UNITED STATES PATENT AND TRADEMARK OFFICE

APPLICATION NO.	FILING DATE	FIRST NAMED INVENTOR	ATTORNEY DOCKET NO.	CONFIRMATION NO.
10/671,842	09/25/2003	Michael D. Brookshire	121236.00003	9648
26707	7590	08/14/2006	EXAMINER	
QUARLES & BRADY LLP RENAISSANCE ONE TWO NORTH CENTRAL AVENUE PHOENIX, AZ 85004-2391			REESE, DAVID C	
			ART UNIT	PAPER NUMBER
			3677

Office Action Summary

DETAILED ACTION

[7] Claims 13-16 and 23-25, are rejected under 35 U.S.C. 103(a) as being unpatentable over Stafford, US-D370642.

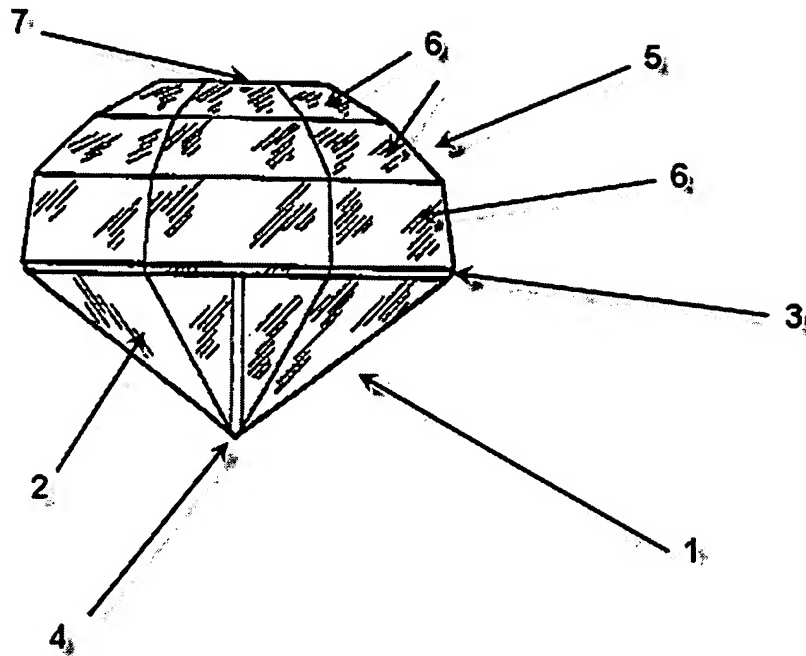
As for Claim 13, Stafford teaches of a diamond (see figure below), comprising:

a pavilion (1) extending from a girdle (3) to a culet (4), wherein the girdle (3) extends no further than a widest circumference of the crown (5) and the pavilion (1) extends no further than a widest circumference of the girdle (3); and

a crown (5) in the form of a symmetrical hemisphere having a first set of facets (first 6) disposed above the girdle (3) and a second set of facets (second 6) disposed between the first set (first 6) of facets and an apex (7) of the crown (5), wherein the first set of facets (first 6) is cut at a first angle with respect to a reference line which is tangential to the apex (7) of the crown (5) and the second set of facets (second 6) is cut at a second angle with respect to the reference line which is less than the first angle, each of the sets of facets (first and second 6) having an equal number of facets (6).

The difference between the claim and Stafford is that Stafford does not expressly disclose that the crown (5) has at least ten sets of facets between the girdle (3) and the apex (7) of the crown (5). It would have been an obvious matter of design choice to modify Stafford (adding additional sets of facets between the girdle and apex of the crown so as to go from 3 sets to at least 10 sets of facets), since applicant has not disclosed that such a particular orientation creates any unexpected result. It appears that the invention would perform equally well as the invention disclosed by Stafford. It is extremely old, well known, readily apparent and profoundly obvious to change the size, shape, number, orientation, angles, percentages, and create ranges for facets and the gemstone in its entirety as to merely alter the aesthetics of said gemstone for the corresponding and resulting properties including brilliance, radiance, etc. for the utility of mere user preference. It is also extremely well known that altering said features will produce different properties radiating from said gemstone, depending on the changes and alterations made.

As for Claim 23, Stafford teaches of a diamond (see figure above), comprising:
a pavilion (1) having a plurality of facets (2) disposed from a girdle (3) to a culet (4); and
a dome-shaped crown (5) disposed above the girdle (3), wherein the girdle (3) extends no further than a widest circumference of the dome-shaped crown (5) and the pavilion (1) extends no further than a widest circumference of the girdle (3), the dome-shaped crown (5) formed from a at least ten sets (in view of that discussed from Claim 13 above) of facets (6) cut with monotonically decreasing angle to form a curved contour in accordance with a dome shape from the girdle (3) to an apex (7) of the dome-shaped crown (5).
